ITEM: 6.1	REPORT SUMMARY MINOR VARIANCE APPLICATION FILE NUMBER A017/24
------------------	--

**MINOR VARIANCE APPLICATION
FILE NUMBER A017/24
16 Venkata Dr Kleinburg ON L4H 3X9**

CITY WARD #:	1
APPLICANT:	Shams Al Deen Yousif
AGENT:	Ken Dimakarakos
PROPERTY:	16 Venkata Drive, Kleinburg
ZONING DESIGNATION:	See below.
VAUGHAN OFFICIAL PLAN (2010) DESIGNATION:	Vaughan Official Plan 2010 ('VOP 2010'): "Low-Rise Residential".
RELATED DEVELOPMENT APPLICATIONS:	None
PROPOSAL:	Relief from the Zoning By-law is being requested to permit proposed walk-up stairs in the southerly side yard and an existing cabana, shed and swimming pool.

1 SITE PLAN
A000 1 : 125

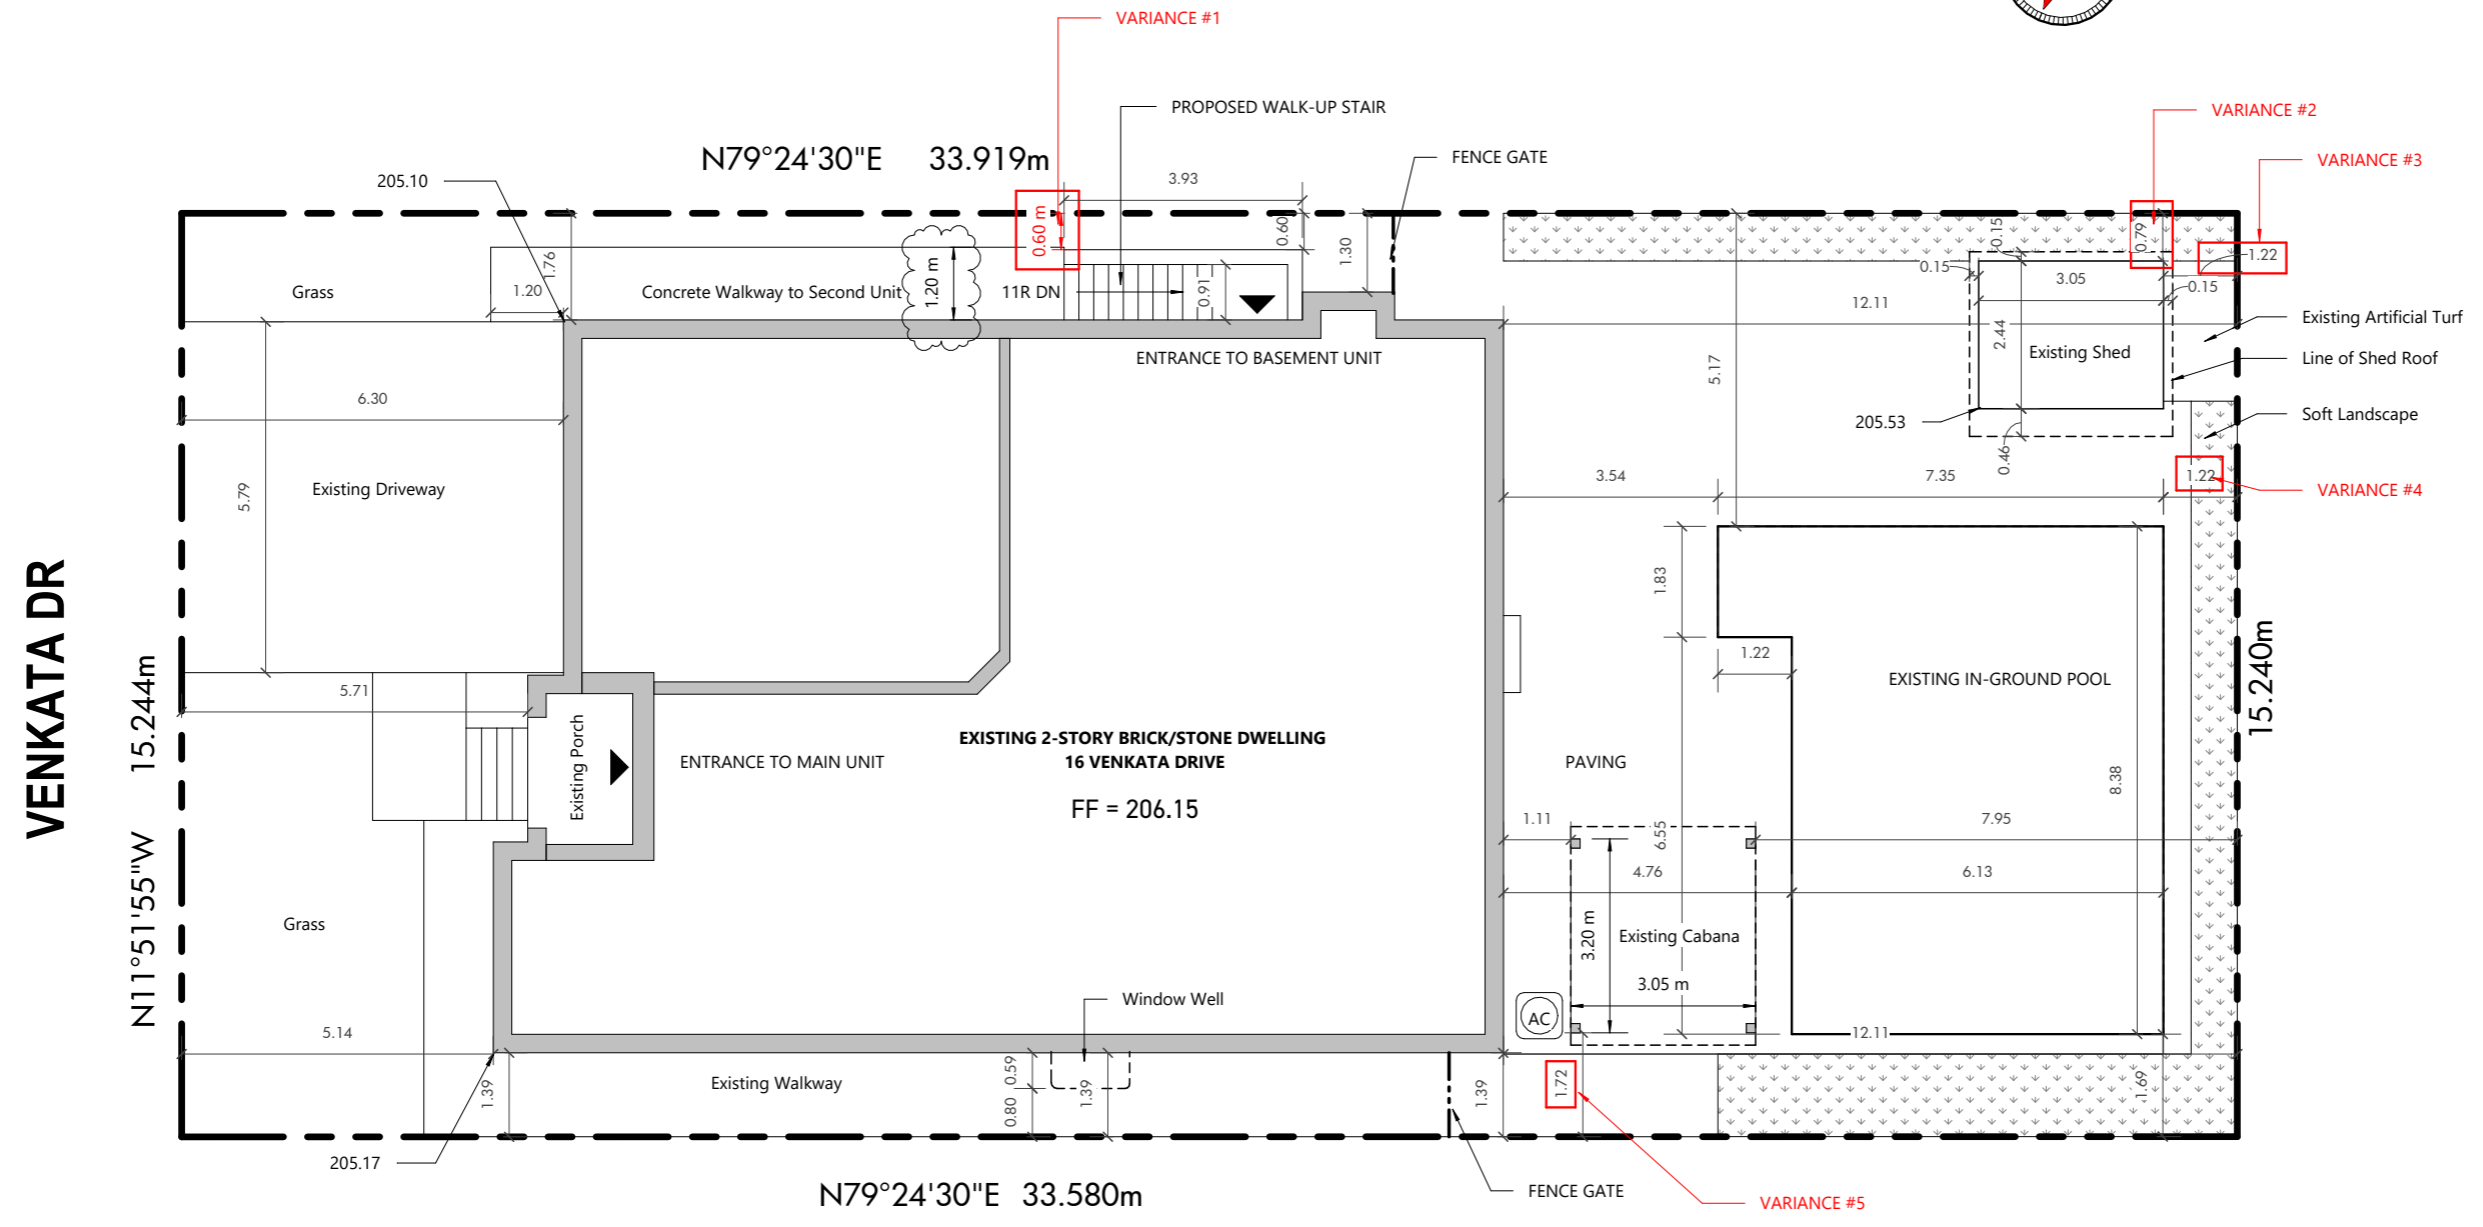
Applicant to please consult with the Building Standards Department at (905) 832-8510 to determine if building permits are required for the residential accessory structures shown on the Site Plan.

Development Planning Department Staff ('Development Planning Staff') have no objection to the requested variance for an encroachment into the required interior side yard setback for the proposed stairs to the basement unit (Variance 1). The secondary suite (basement) door is proposed to be located on the south wall of the dwelling in the interior side yard, below grade. The door would be accessed via a sunken landing with

Development Planning Staff have no objection to Variance 4 for the in-ground swimming pool. A 0.28 m reduction to the required rear lot line setback for the existing in-ground swimming pool is proposed. There are existing cedars planted along the rear yard lot line which helps provide a vegetative buffer between the existing pool and rear lot line to buffer any adverse impacts the modest reduction may generate, which is not anticipated to be perceptible. The requested rear yard setback provides sufficient space for safe maintenance access of the pool.

DRAWING:
SHED ELEVATIONS

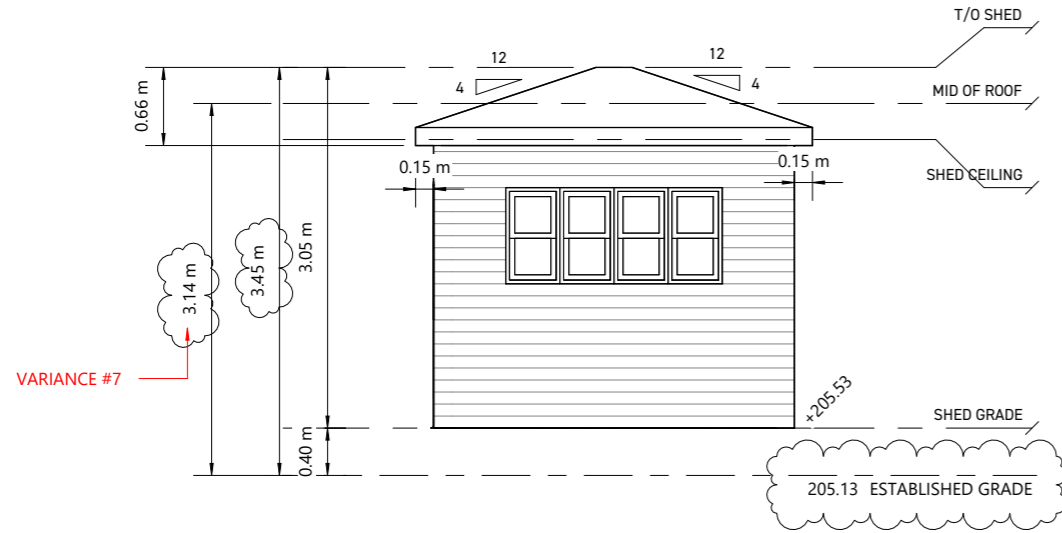
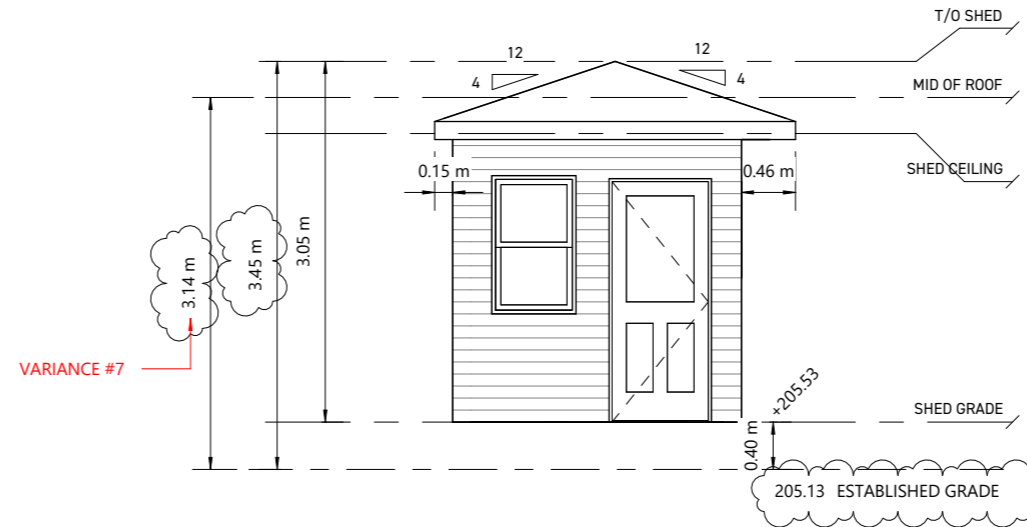
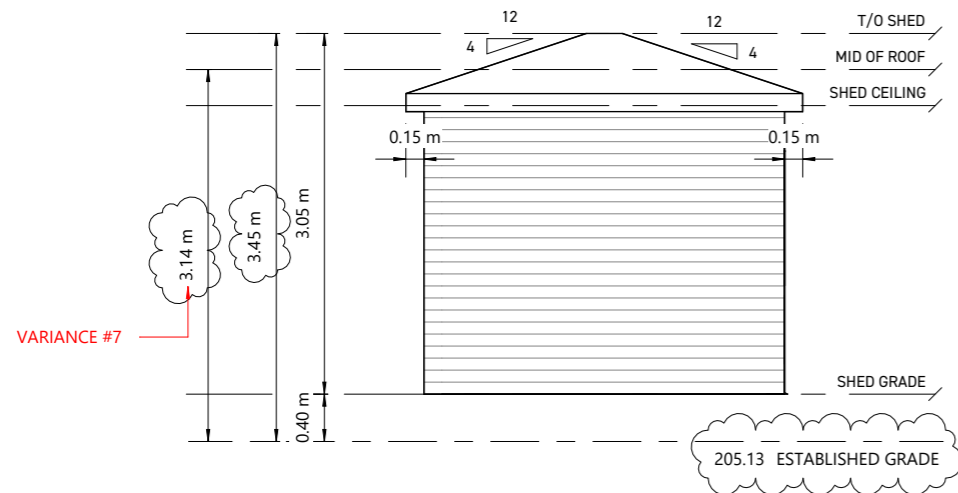
Development Planning Staff have no objection to the request to permit a reduced interior side yard setback (Variance 2), a reduced rear yard setback (Variance 3), as well as an increased maximum height (Variance 6) for the existing shed. The requested 0.14 m increase to maximum height permitted for an accessory structure (shed) is negligible from a visual perspective when paired with the modest footprint and hip roof design. The shed exists in the south-west corner of the rear yard and complies with maximum lot coverage requirements of the Zoning By-law for accessory buildings and structures. Its modest footprint ensures the length of wall facing the abutting lot lines is minimal. Sufficient space remains between the shed and fence for maintenance access. Therefore, the shed is not anticipated to have adverse use (privacy) or massing impacts on the neighbouring property to the south (12 Venkata Drive) or properties to the west (82 and 88 Torrey Pines Road), and the 0.79 m minimum interior side yard setback from the accessory structure provides sufficient space for maintenance and access purposes.

DRAWING:
CABANA ELEVATIONS

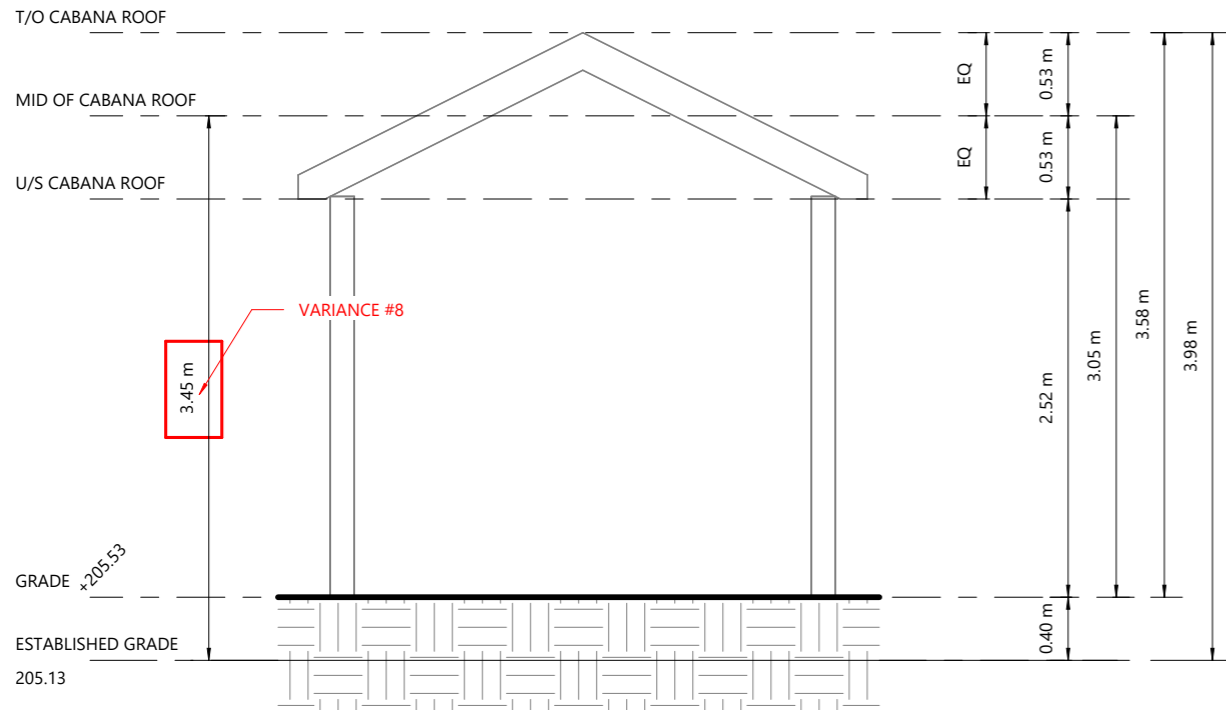
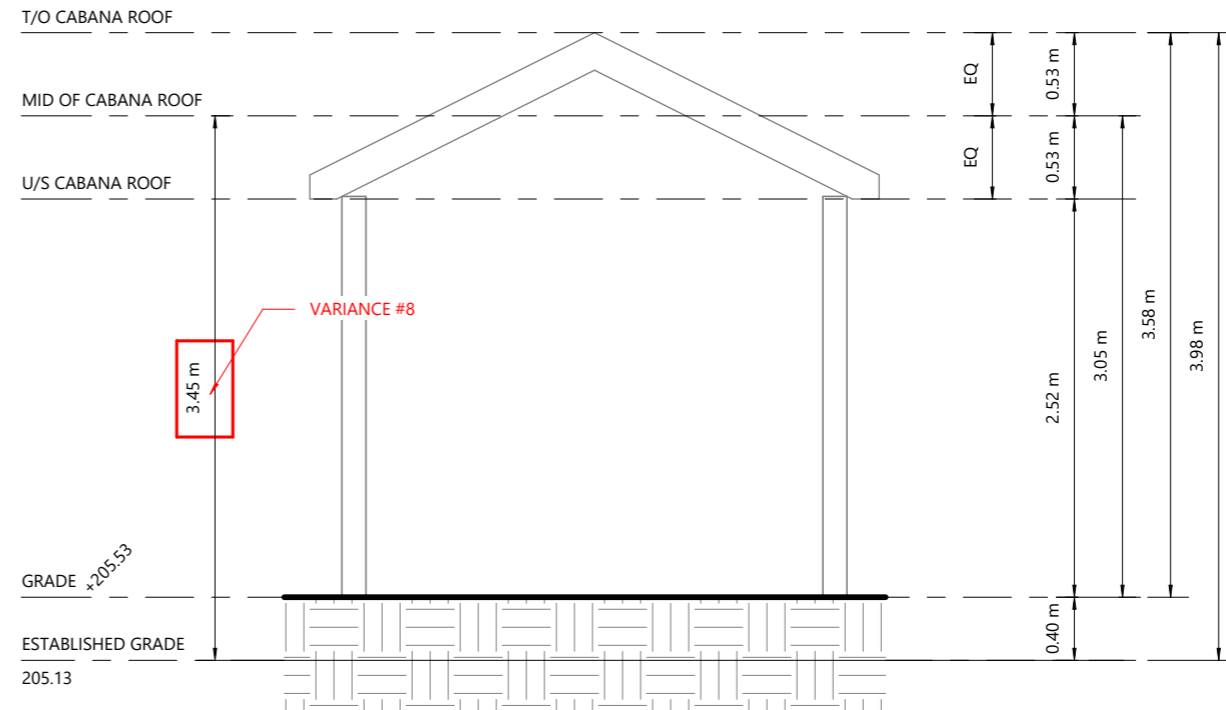
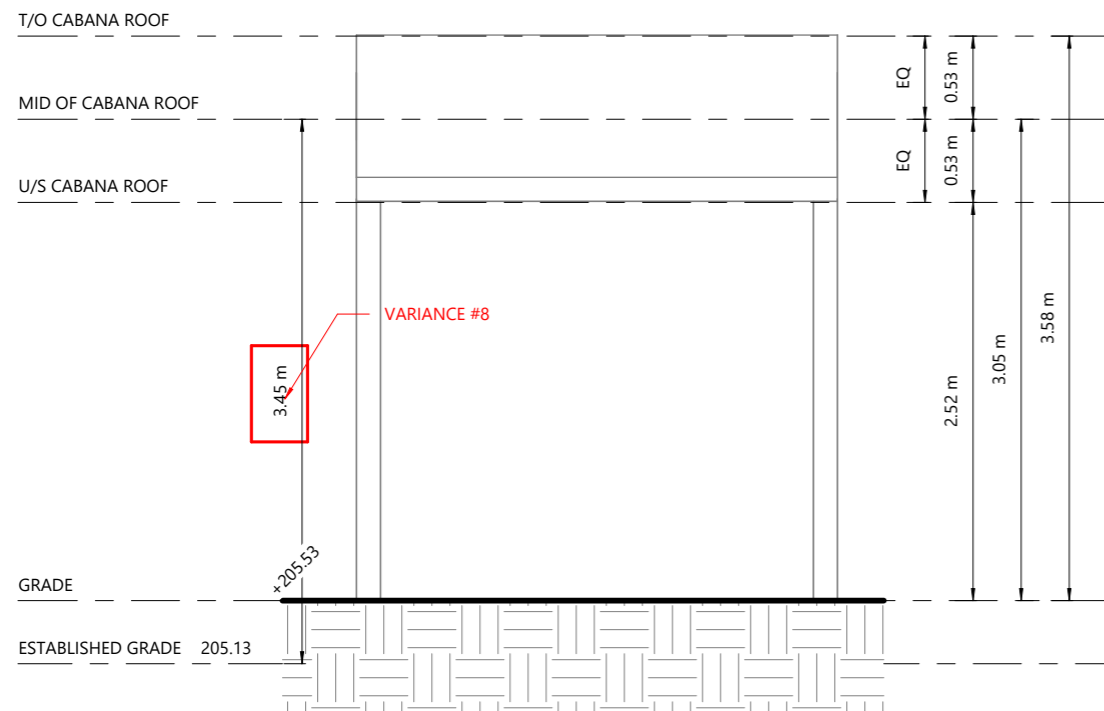
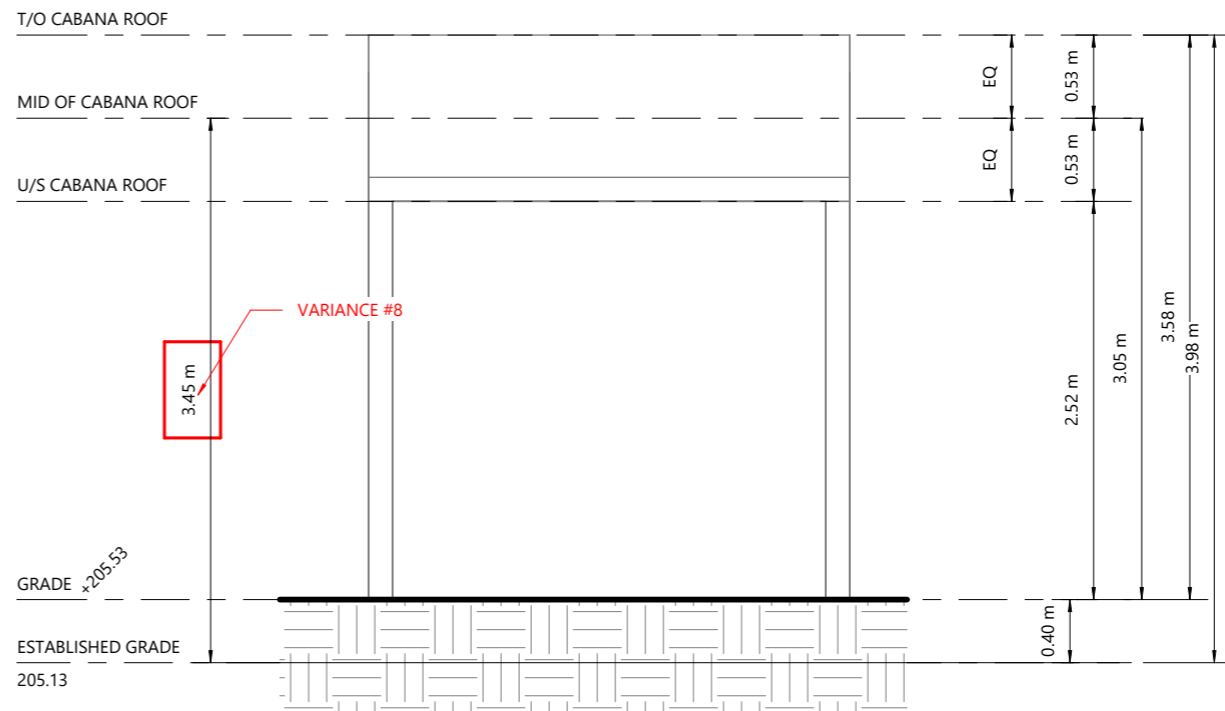
Development Planning Staff have no objection to the request to permit a reduced interior side yard setback (Variance 5) and an increased maximum height (0.45 m measured to the mid-point of the roof) for the existing cabana (Variance 7). The cabana exists in the north-east corner of the rear yard and is modest in size and it complies with maximum lot coverage requirements of the Zoning By-law for accessory buildings and structures. The structure is fully open on all four (4) sides, the peak of the gable roof faces the rear lot line, and it will be partially screened by cedar trees planted along the side (north) lot line. All these features assist in alleviating any perceived concerns with the massing of the structure on the neighbouring property, 20 Venkata Drive, to the side (north) as a result of the requested height increase. No adverse impacts are anticipated to yards to the rear (west) due to the spatial separation the cabana maintains to the rear lot line. As such, the cabana is not anticipated to have adverse use (privacy) or massing impacts on the neighbouring property to the north (20 Venkata Drive) and the 1.72 m minimum interior side yard setback from the accessory structure provides sufficient space for maintenance and access purposes, as well as for the existing cedar plantings.
